Product Change Notification / JAON-15XJYR211

CCB 5299 Initial Notice: Qualification of MTAI as an additional final test site for MIC79110-4.2YML-TR and MIC79110YML-TR catalog part numbers (CPN) available in 10L VDFN (3x3x0.9mm) package.

Pre and Post Change Summary

PCN# JAON-15XJYR211

Pre and Post Change Summary – Carrier Tape

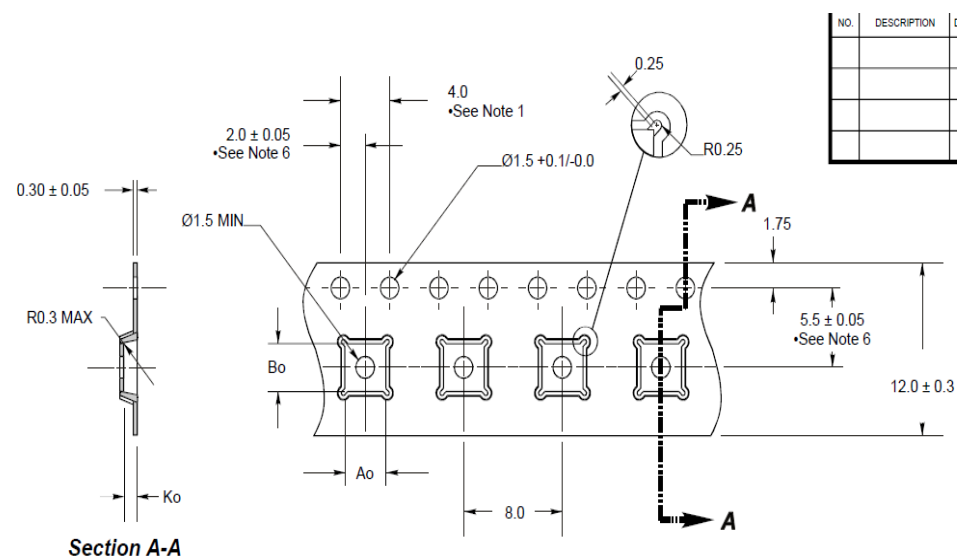
UNIS

Section A-A

A₀ = 3.3 mm
B₀ = 3.3 mm
K₀ = 1.1 mm

Supplier	W (mm.) ±0.3 or Specific	P (mm.) ±0.1 or Specific	A ₀ ±0.1 or Specific	B ₀ ±0.1 or Specific	K ₀ ±0.1 or Specific	Thickness ±0.05
Supplier A	12	8	3.30	3.30	1.00	0.30
Supplier B	12	8	3.30	3.30	1.10	0.30

Pre and Post Change Summary – Cover Tape

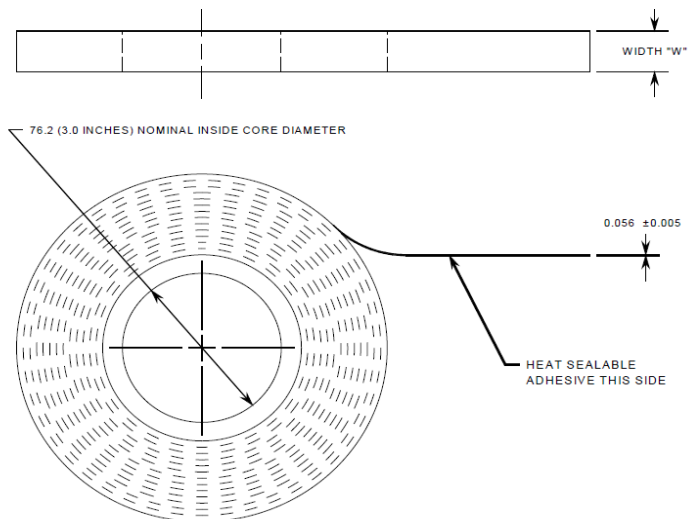
Plant	Package	Carrier Tape Width	Cover Tape Width	Thickness of Cover Tape	Color of Cover Tape	Sealing mythology
UNIS	10L VDFN 3x3	12mm	9.2mm	0.056mm	Clear	Heat sealing
MTAI	10L VDFN 3x3	12mm	9.05+0.05/-0.15mm	0.050 ±0.010mm	Clear	Heat sealing

UNIS

MTAI

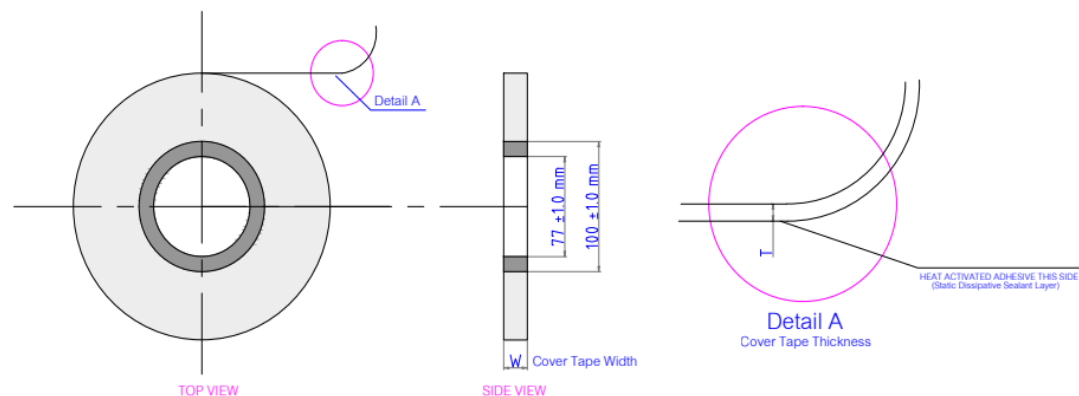
Plant	Package	Carrier Tape Width	Cover Tape Width	Thickness of Cover Tape	Color of Cover Tape	Sealing mythology
UNIS	10L VDFN 3x3	12mm	9.2mm	0.056mm	Clear	Heat sealing
MTAI	10L VDFN 3x3	12mm	9.05+0.05/-0.15mm	0.050 ± 0.010mm	Clear	Heat sealing

Pre and Post Change Summary - Reel

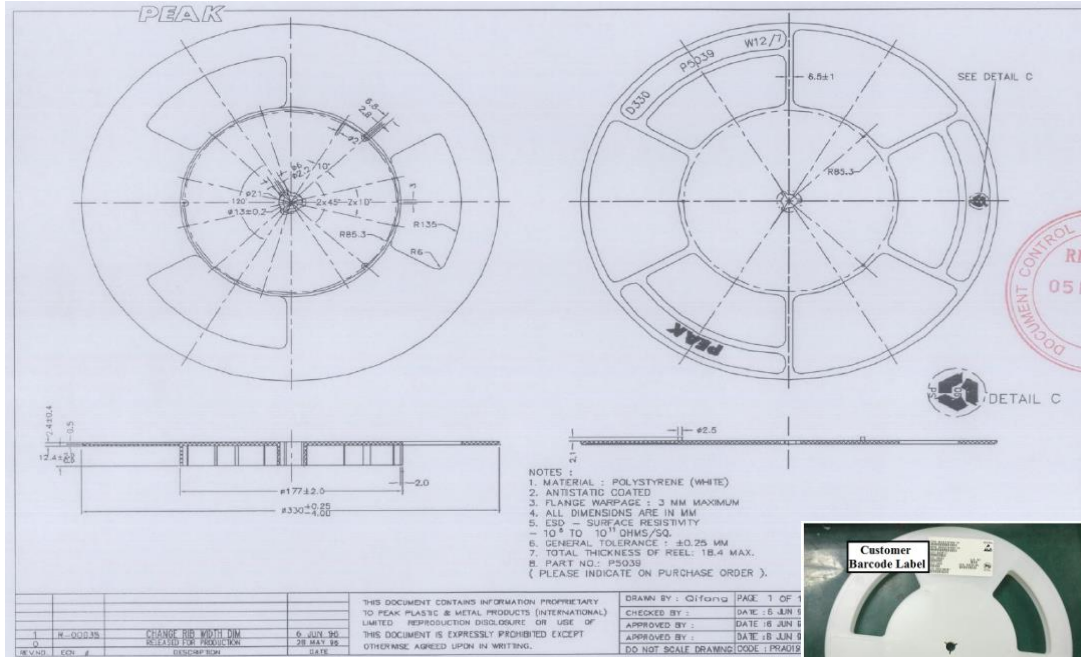
UNIS

Color: White

Plant	Package	Carrier Tape Width	Reel Diameter (mm.)	Reel Hub Size (mm)	Reel Width Max (mm.)	Color
UNIS	08L VDFN 3x3	12mm	330 +4.0/-0.25	177 ±2.0	18.40	White
MTAI	10L VDFN 3x3	12mm	330 ±2.0	100 ±2.0	18.40	Dark Blue

MTAI

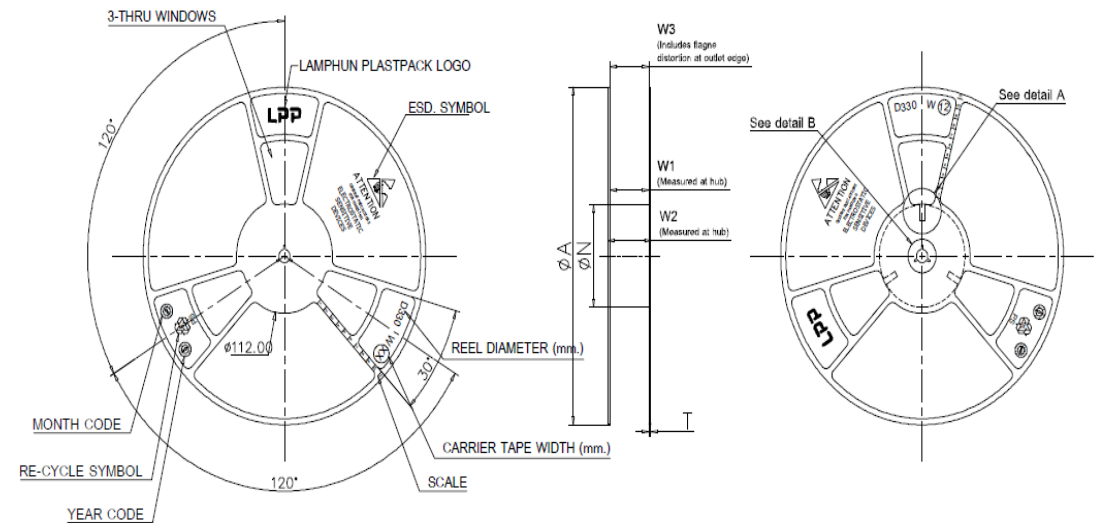
Color: Dark Blue

Pre and Post Change Summary – Packing Method

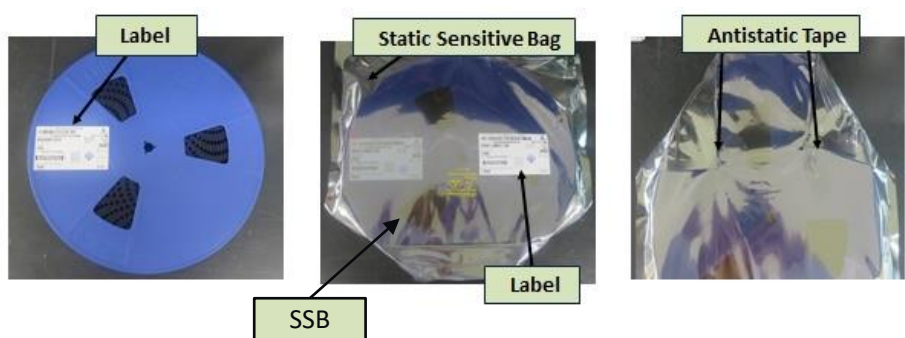
UNIS

MTAI

MSL-1 (No inner box)

Carton	Dimension W x L x H (cm)	Number of reel per carton
		Reel diameter (D) = 330mm
		Carrier Tape Width 12mm
M01-011 (TT)	36.5x38x39.5	15
M01-012 (B1)	35.5x35.5x2.8	1
M01-013 (B2)	35.5x35.5x4	2
M01-014 (B3)	35.5x35.5x6	3
M01-015 (B8)	35.5x35.5x16.5	8
